Design Note Documentation

This document details Design Notes for the following silicon:

Document number: DN-IOP 480 Rev AA-SIL-1.3

13. ALE Output Timing

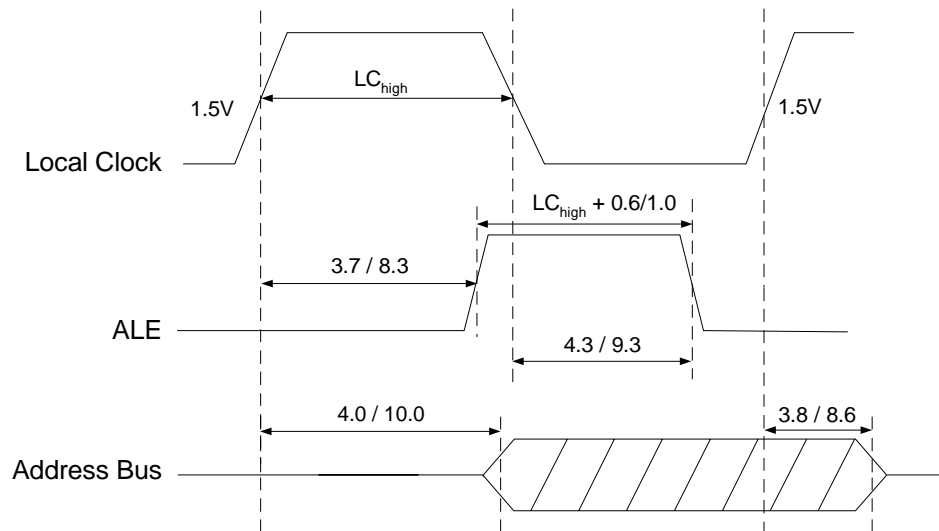
Figure 19-1 in the IOP 480 Data Book r1.0 and r2.0 shows a Timing Diagram for the ALE signal that is incorrect. ALE timing is dependent on the Local Clock period, which was not shown in the existing diagram.

1. The following diagram correctly shows the ALE timing specifications:
